## Meera Smethurst response to Written Representations and Local Impact Reports, Deadline 2

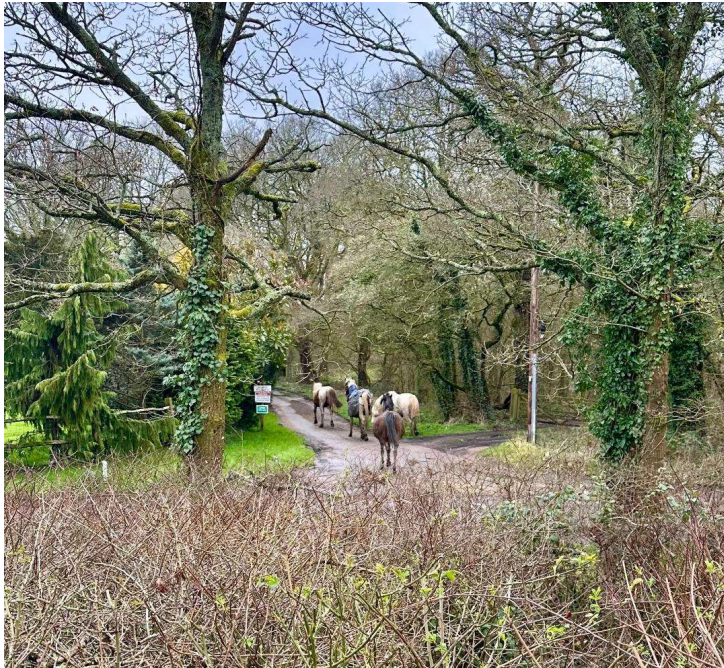
The photograph below shows a group of horses turning off Kent Street onto a side lane. This demonstrates Kent Street's total unsuitability for any construction traffic. Most of the current traffic

is pedestrians, dogs and horses. How will Rampion manage them?
